HISTORIC LANDMARK COMMISSION STAFF REPORT

PLNHLC2011-00296 Gutarra Residence Window Replacement 632 South 700 East October 20, 2011

view for the south side where windows will be replaced

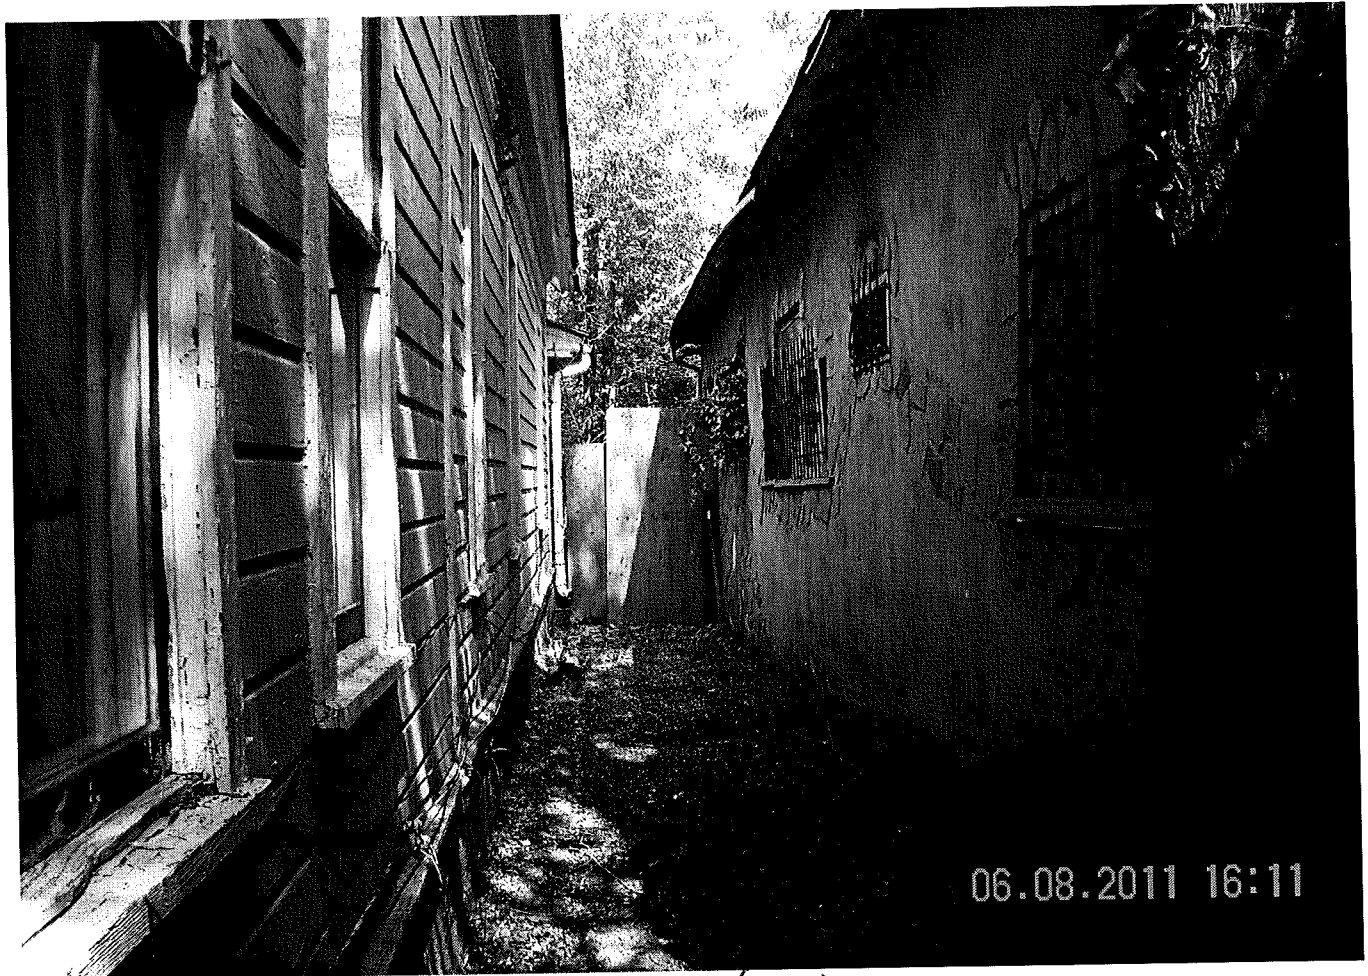
Salt Lake Community Action program proposes to replace the windows on the South side of this house as a part of the scope of work for weatherization. The windows we install in homes are vinyl amsco double pane energy efficient windows. We are a non-profit agency weatherizing homes for low income people, and our budget doesn't allow us to purchase expensive wood windows. Currently the windows are in very bad shape and are losing a lot of heat in the winter. They are single hung and will be replaced with single hung windows.

These windows are not visible from anywhere other than the neighbors house, (which is vacant and boarded up), therefore the adverse effect on the historic neighborhood will be minimum to none.

Front View of Subject Property

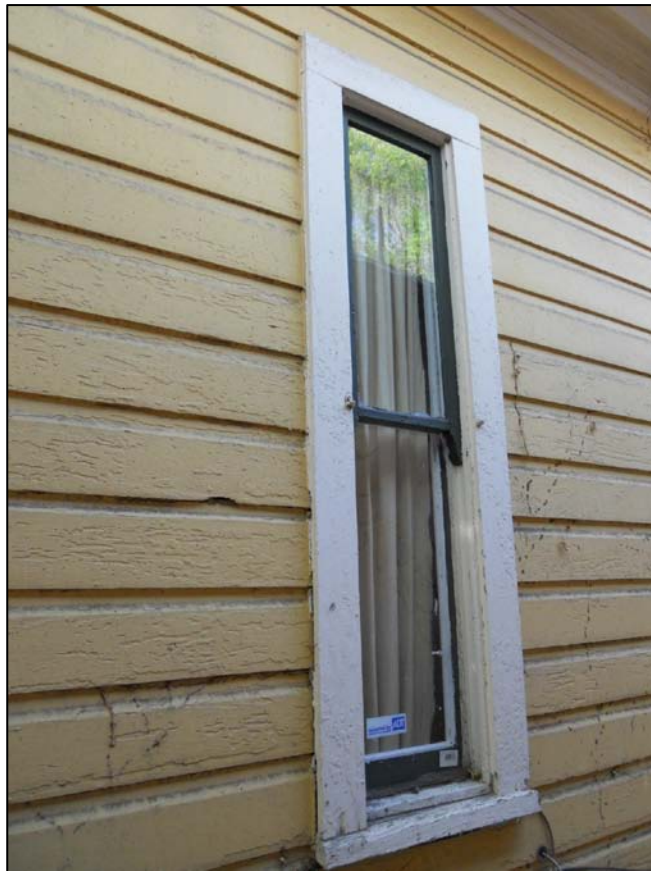
The loss of the five (5) subject windows will be mitigated by two factors. One, the subject windows are not visible from the street. The subject windows face an abandoned residence to the south. Two, the window sills will be preserved where possible (one window sill may have to be replaced upon further investigation). The preservation of the window sills will help retain the historic character of the home.

The existing window sills will remain in place with only the windows being replaced. Also, the subject windows are not viewable from the street making their replacement more palatable. Based on this evaluation, the request does meet the intent of the standard.
